VALIDATION REPORT

Title of the project activity	Ecofiltro Guatemala Improved Stoves and Water Purification Project
Version number of the validation report	03
Completion date of the validation report	09/02/2020
Version number of PDD to which this report applies	Version: 6.0; Dated: 17/01/2020
Date when PDD was uploaded for global stakeholder consultation	N/A
Project participant(s)	Ecofiltro S.A., Natural Capital Partners
Host Party	Guatemala
Estimated annual average GHG emission reductions or net removals in the crediting period (tCO₂e)	175,243GS VERs/year
SDG Impacts:	1. Financial savings from wood savings by using the efficient stove and saving time to allocate in other beneficial activities that will decrease the poverty level (SDG 1.1). 2. Removal of 99.99% of pathogens avoiding water-borne diseases (SDG 3.3). 3. Improvement in air quality, reduction of respiratory diseases and air contamination (SDG 3.9). 4. The water filter achieve universal and equitable access to safe and affordable drinking water the Guatemalan people (SDG 6.1). 5. The high quality improved stove replace inefficient traditional three stone fire and ensures access to affordable energy for cooking (SDG 7.1)

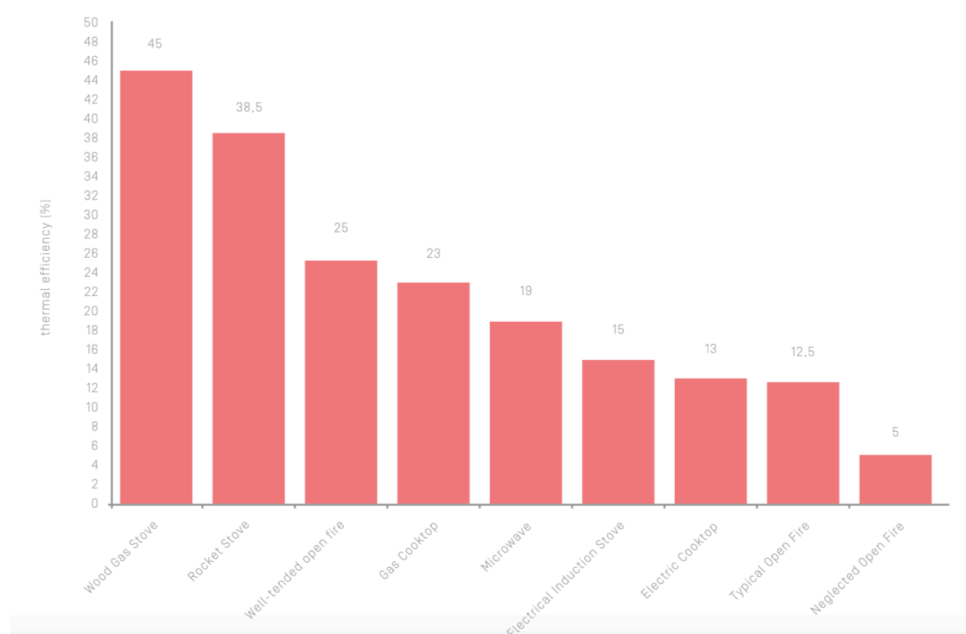
CL ID	01	Section no.	Date: 31/10/2019
Description of CL			
As per the PDD, the thermal efficiency of Ecostove is 15.4 %. Project Participant is requested to clarify as how this qualify and generate emission reduction. While doing so please also refer to the foot note 24 of the applied methodology, where even the more advanced baseline stoves could have 20% thermal efficiency.			
Project participant response			Date: 04/11/2019
It is pertinent to mention that the 15.4% of thermal efficiency for the Ecostove was a test result done in a laboratory in California through a WBT, and the value is for a Cold Start test and therefore is not representative of the main cooking practices in Guatemala or the environment of rural households. The PP has not replicated this laboratory test because this will not impact on emission reductions directly, the PP has followed and will continue to use the GS Methodology request on using Kitchen Performance Tests to assess wood savings, and therefore, emission reductions.

The PP has always followed the protocol looking for transparent results, and as can be seen in the table below, wood consumption has been very similar in every issuance, and has been accepted for 6 years of performing the field tests.

According to several studies, the WBT is not an adequate method for measuring fuel savings. In 2016 IEEE Global Humanitarian Technology Conference (GHTC) gave the conference called **Insights on thermal efficiency analysis for the water boiling test**, where this information can be found: "There is a lack of applicability that the WBT has on tasks other than boiling water. This lack of applicability will vary in importance depending on the most common meals cooked in a specific part of the world. While many dishes are very similar to boiling water (such as soups, stews, etc), there are also many dishes that are not very similar to boiling such as tortillas, beans and other flatbreads".

Quoting the Technical brief in Cookstoves & Energy Efficiency from the Energy and Environment Partnership, "The human behaviour directly influences the performance of the multi-variable cooking operation. The energy efficiency of a clean cookstove is not only device dependent, but is significantly influenced by the user's fuel measurements and operation. As it is demonstrated in the following figure, which indicates the significant efficiency difference between a well-tended open fire (25% efficient) compared to a neglected three-stone fire (5% efficient). Given that cookstove efficiency is usage-dependent, some tests advocate efficiency measures for cooking typical dishes. Heterogeneous Testing Protocols refer to testing a device at all the power levels with different sized pots of water. These protocols are modelled on culturally appropriate cooking practices".
